ENVIRONMENTAL REVIEW COMMITTEE REPORT

Project Name: Barbee Mill Watercraft Lifts

File Number: LUA10-050, ECF, SM, SMC

Project Summary: The applicant requests SEPA Review for the installation of two 10-foot by 14-foot freestanding boatlifts, one 10-foot by 20-foot freestanding boatlift with a fully grated platform, and one dock-mounted jet ski lift in association with an existing joint use dock which serves three single-family residential lots in the R-8 zone. Each of the freestanding watercraft lifts would rest directly on the lake bottom on four 12-inch by 12-inch footpads. The existing fully-grated 118-foot 6-inch dock is comprised of a ramp (4 feet, 6 inches in width, and 31 feet long), and dock (7 feet, 10 3/4-inches in width and 86 feet, 6-inches in length) with two (7-foot 2-inch wide by 27-foot long) fully-grated finger docks. The proposed project also encompasses the removal of six 12-inch diameter creosote-treated wood piles and replacing them with two vibratory pile-driven 12-inch diameter steel piles. All work would take place within the Washington Department of Fish and Wildlife fish window for this section of Lake Washington, July 16 through December 31.

PLOT PLAN

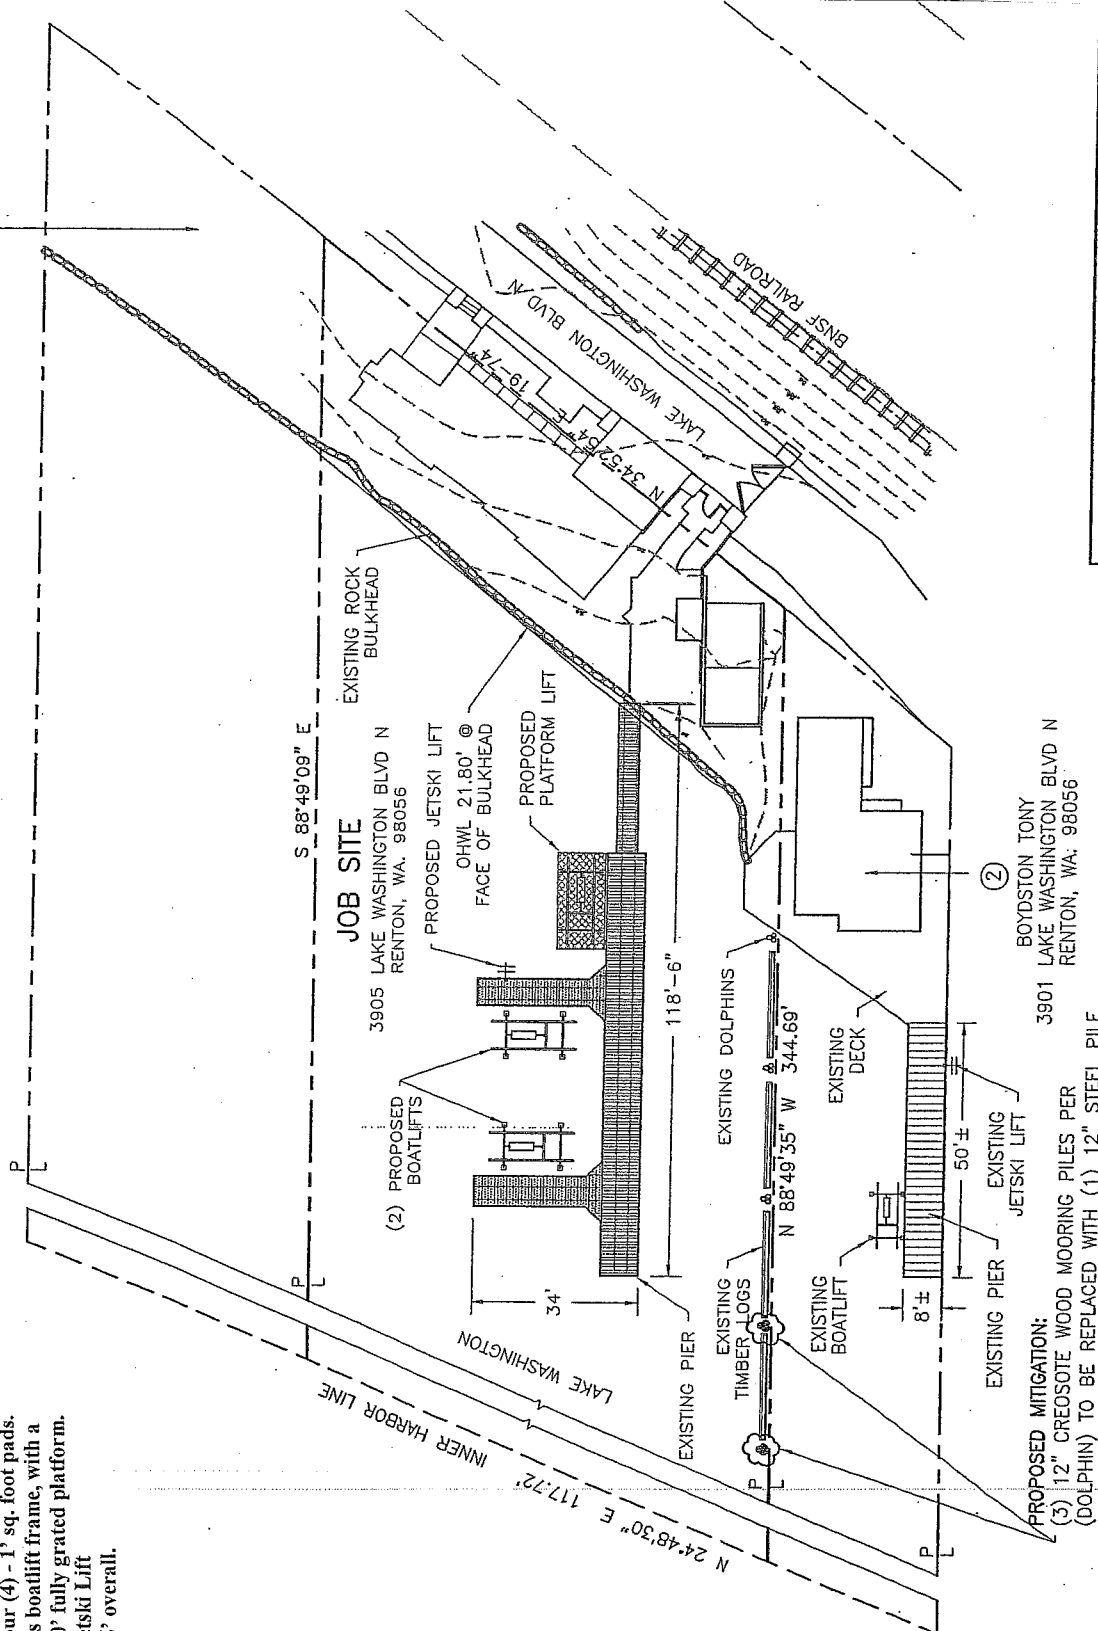
4. The proposed LOP project also is seeking to replace 3- 12 inch diameter creosote wood mooring piles per dolphin for the two outermost dolphins shown on Sheet 2 as mitigation. What is the purpose of the mooring piles and associated log booms? Do these dolphins need to be replaced anyway? Why not replace the two most landward dolphins to get rid of some of the vertical structure in the nearshore environment?

5. Instead of the replacing the two existing dolphins with a single 12 inch diameter steel pile, we recommend that all of the dolphin mooring piles and log boom structure shown along the southern edge of the property in Sheets 2 and 3 be removed as mitigation for the increase in overwater coverage as a result of the new lifts and their associated watercraft. This mitigation measure would reduce inwater structure that potentially provides salmon predators with ambush habitat while meeting the project's purpose since the new lifts will be providing moorage at the existing dock.

- The purpose of the existing piles and the log boom is to protect the moorage from southwest winter storms which are severe in the area, as the sea fetch extends all the way from the southwest side of lower Lake Washington in Renton.

Removal is not an option. The existing structures are in good condition. The proposed purpose is for the Corps RGPI required mitigation, as other options of the RGPI have been established on the site. The outer end of this protective system was elected solely for the mitigation, as with the south adjacent property being only 20'+/- away, there is little accessibility for a barge or equipment to work with the nearshore pylons.

- As mentioned in the original applications, removal of the existing protective log system is not an option for our client. It was elected as a viable form of mitigation for the proposed lifts, in that other mitigation for the property has already been applied to the site. With the deep water throughout the entire area for the proposed lifts, mostly at 20' depth, and at 10'+ at the nearshore end, the positive impact of your suggested handling is likely minimal to the effect that would result in shallow waters.
